303-49

TECHNICAL BULLETIN

"Restricted Performance" Displayed on Message Center – Limp Home Mode – AJ27 SC Engines – Reflash ECM **MODEL**

2000-02 MY XKR 2000-02 MY XJR

ILLUSTRATION 1

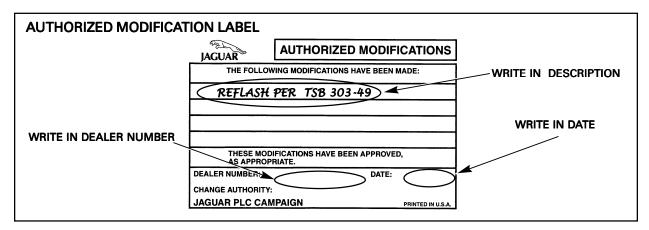
Enter your dealer number and the date on the Authorized Modification Label as shown (Illustration 1). Write in "Reflash per TSB 303-49." Apply the label to the driver side B-post below the door striker plate on XK8 vehicles, and next to the left hood hinge on V8 XJ Series. Be sure to apply the clear protective sheet over the label.
